INDEX OF STRUCTURAL DRAWINGS

**KUHIO HIGHWAY SHORT-TERM
IMPROVEMENTS KUAMOO ROAD
TO TEMPORARY KAPAA BYPASS ROAD**
Fed. Aid Proj. No. NH-056-1(50)

"AS-BUILT"

LAYOUT PLAN
EXTENSION OF EXISTING BOX CULVERT
AT STA. 66+64
Scale: 1" = 10'

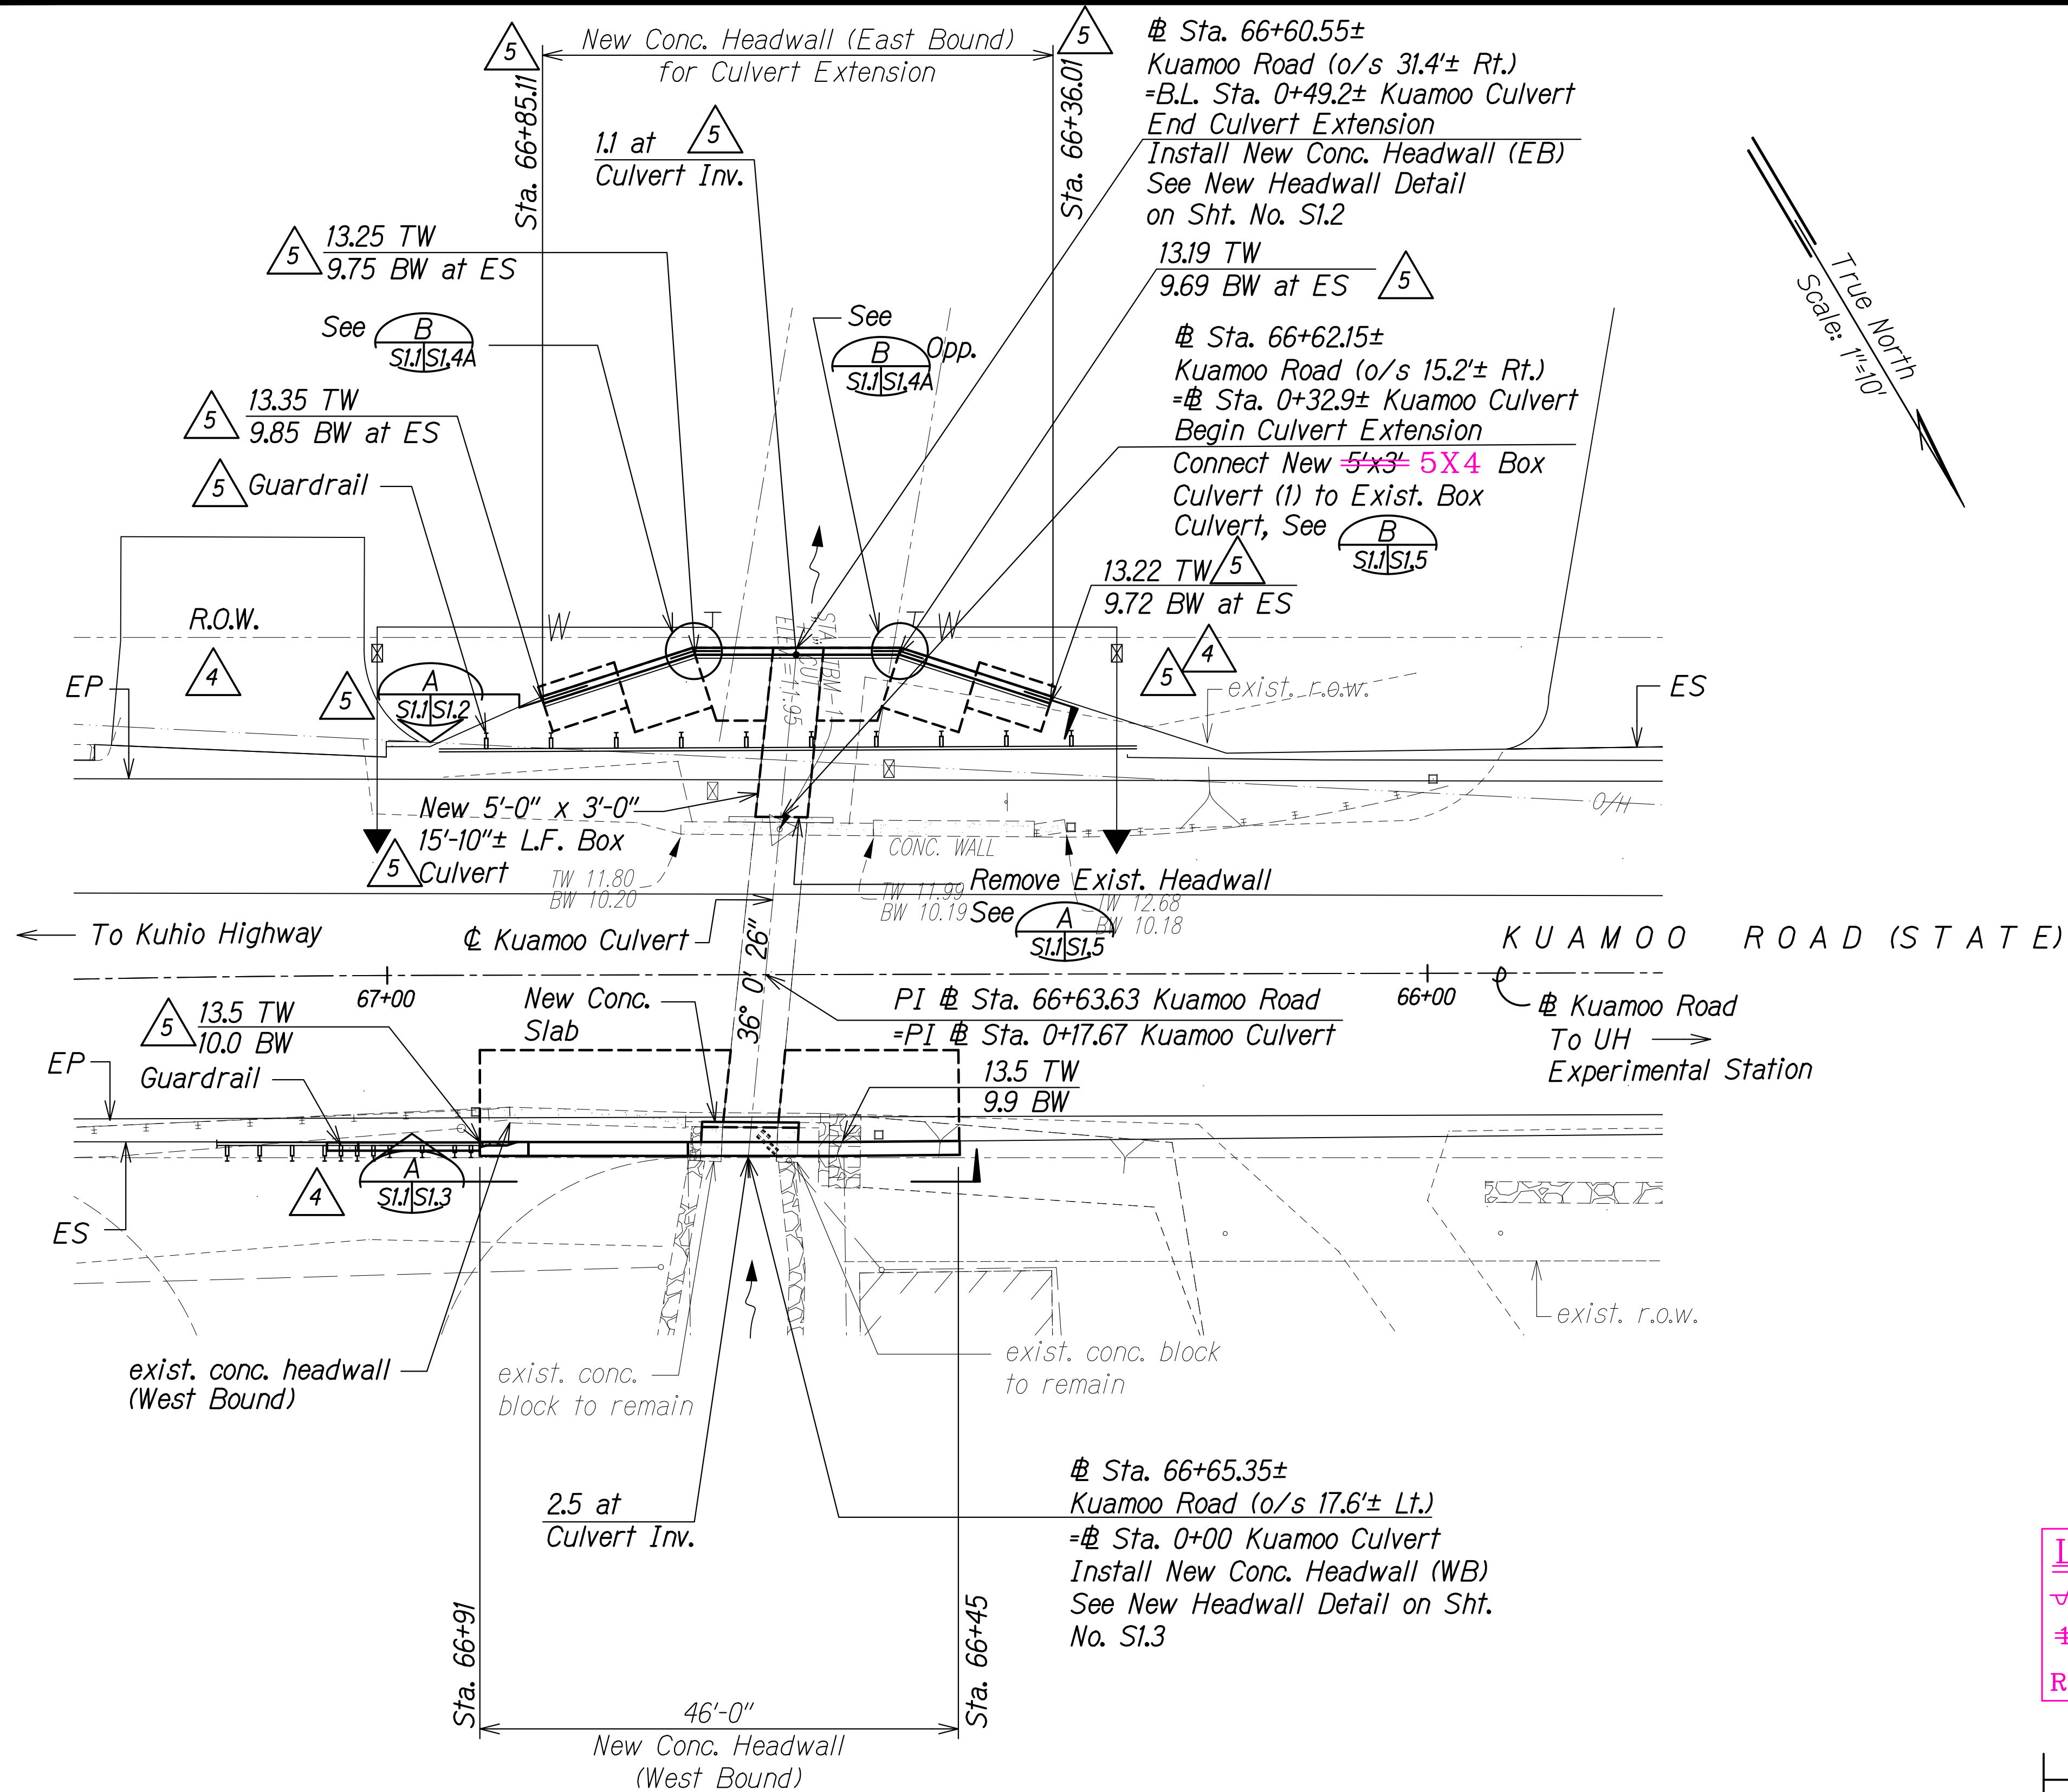
DATE	REVISION
7/5/21	5 C.O. Revised EB headwall.
6/12/20	4 RFI 009 - Barrier Transition
11/12/19	3 Reissuing plan for legibility only. No design changes have been made.
9/20/19	1 Reissuing plan for legibility only. No design changes have been made.

5 HEADWALL SECTION - KUAMOO ROAD (EB) A
Scale: 3/8" = 1'-0" S1.2 S1.2

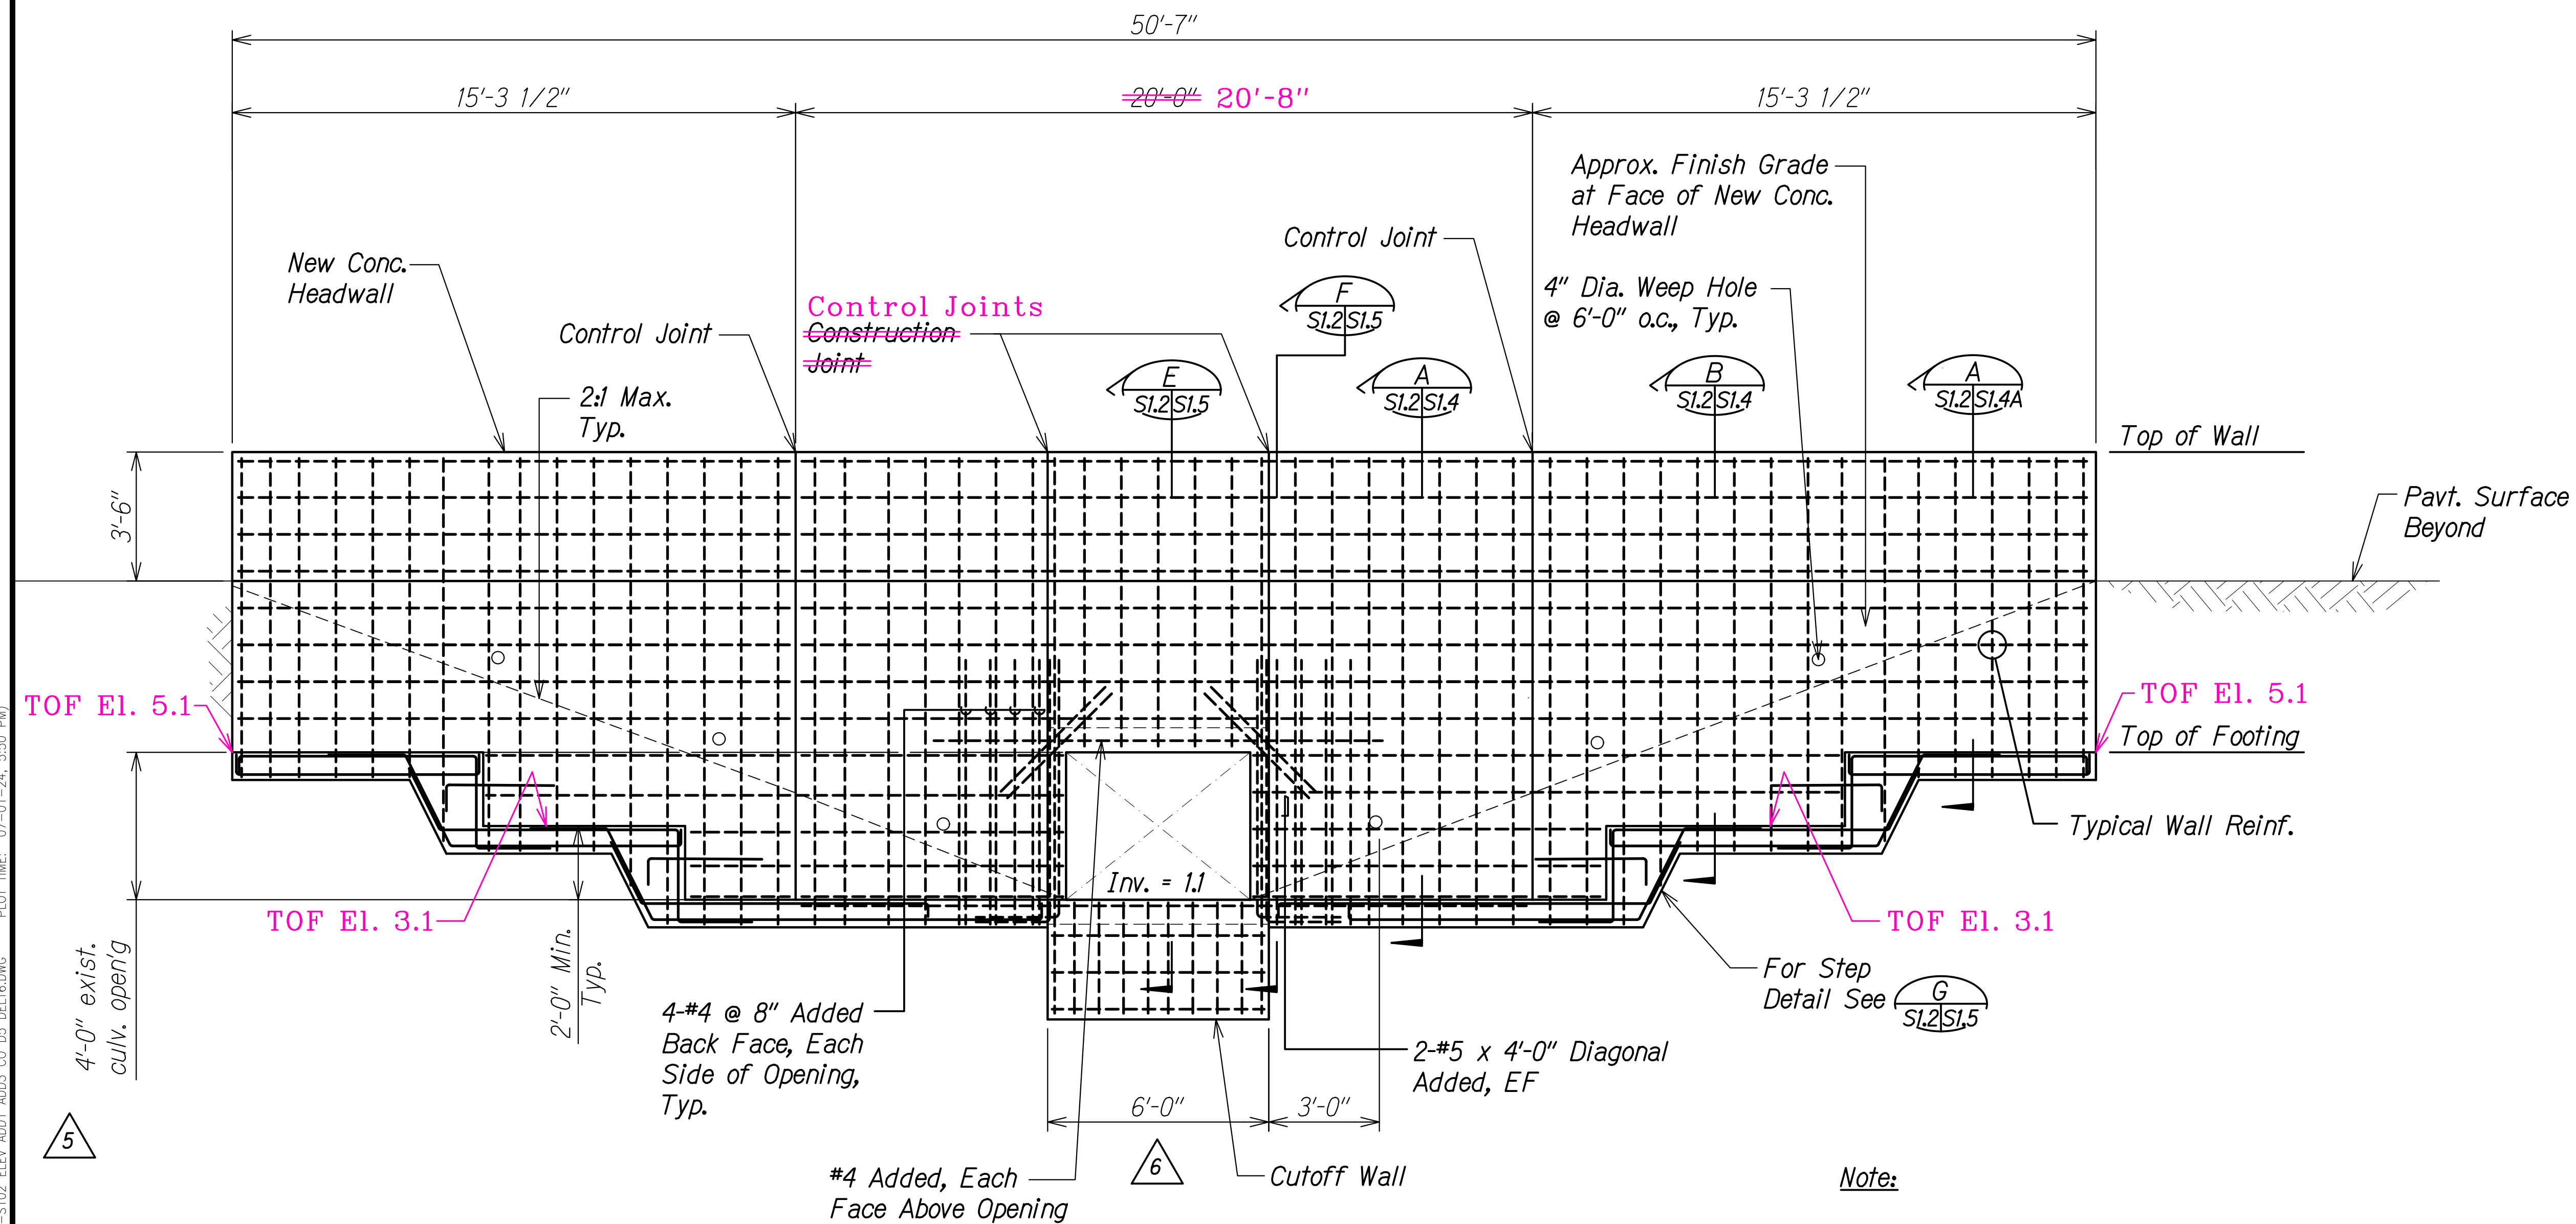
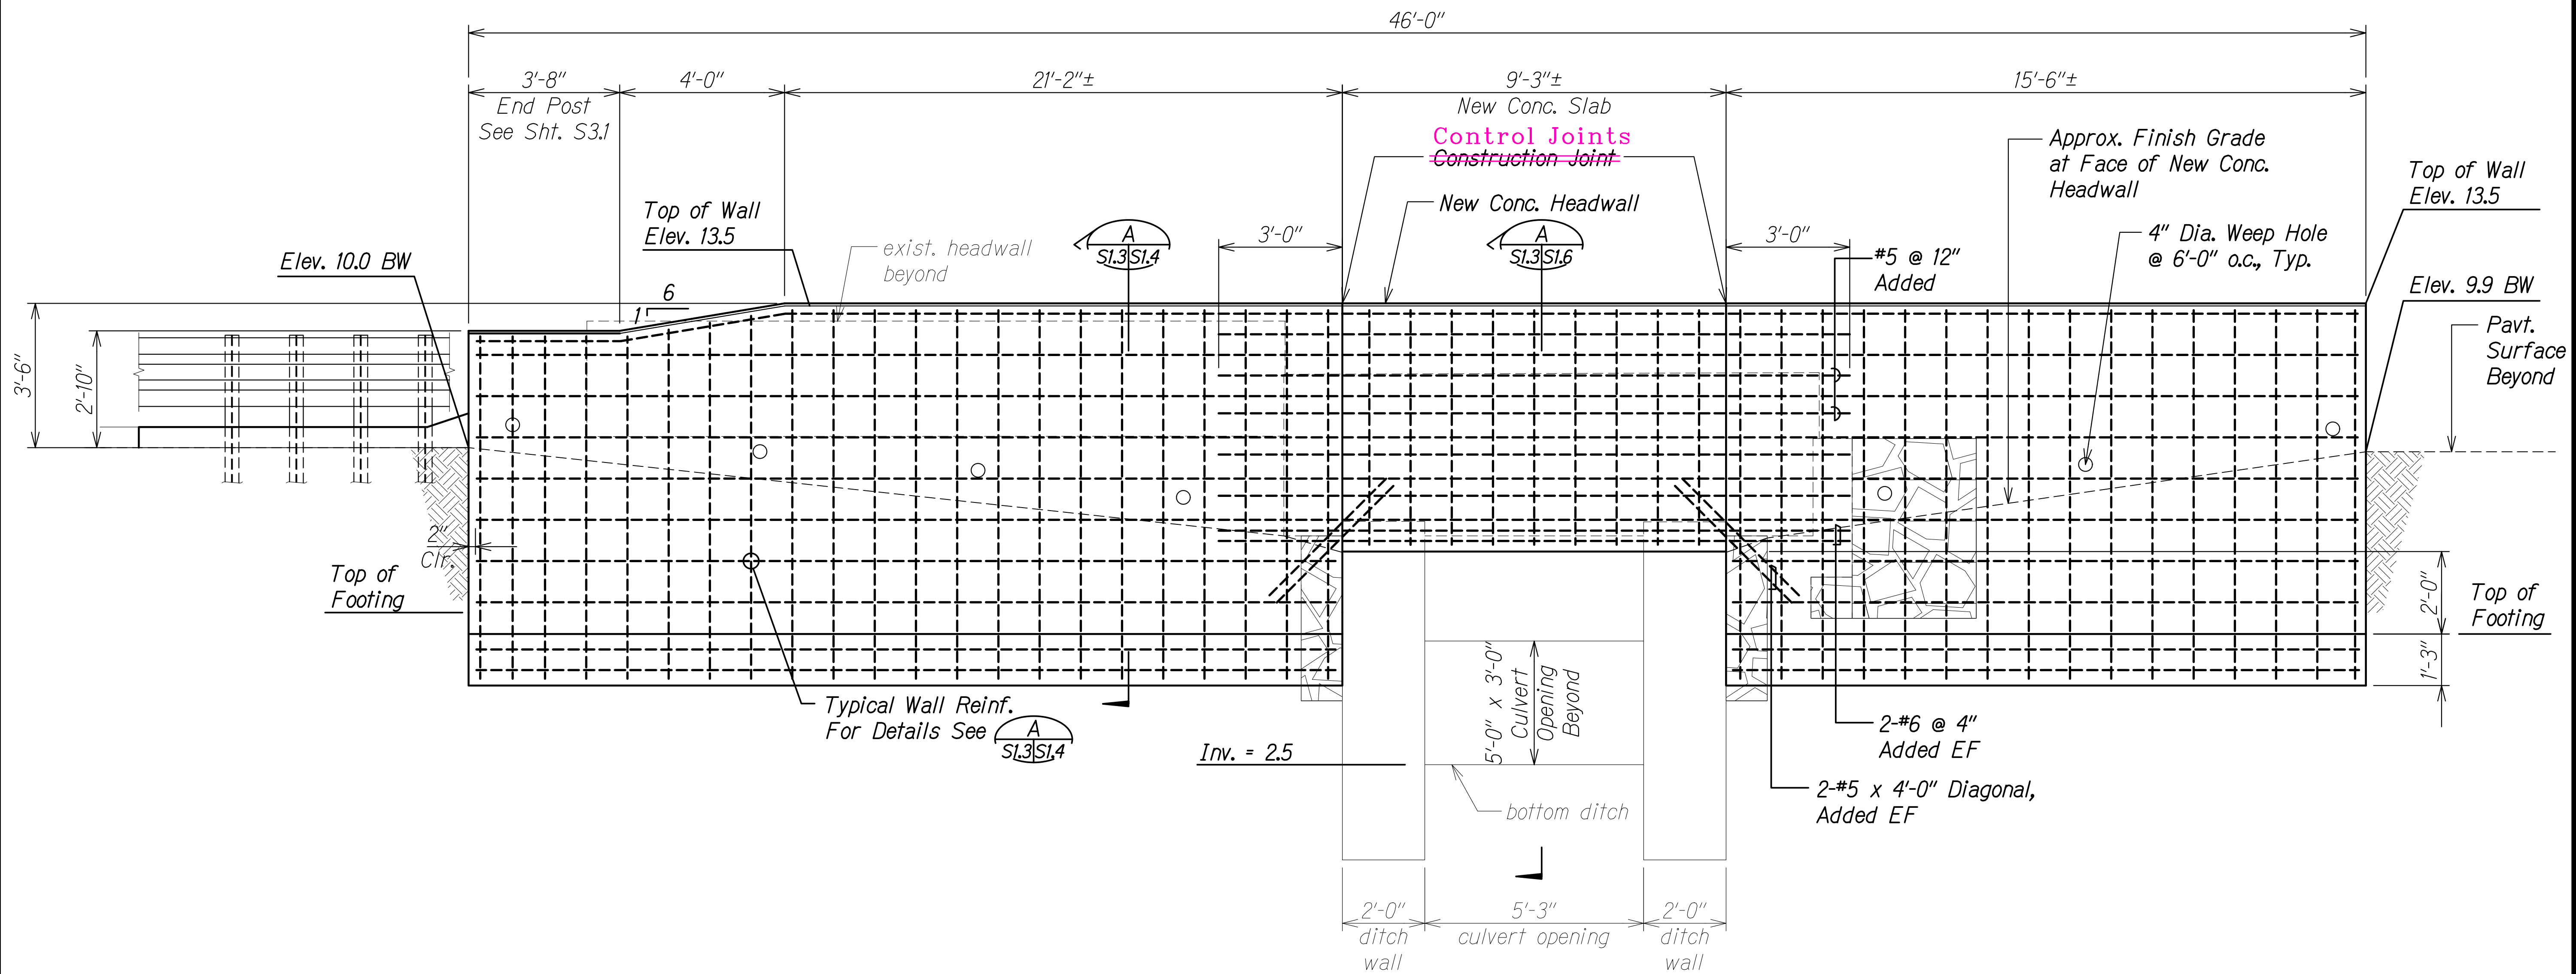
| DATE     | REVISION                                                                |
|----------|-------------------------------------------------------------------------|
| 7/12/21  | 6 Revised exist. box culvert size and new reinf.                        |
| 7/5/21   | 5 C.O. Revised EB headwall.                                             |
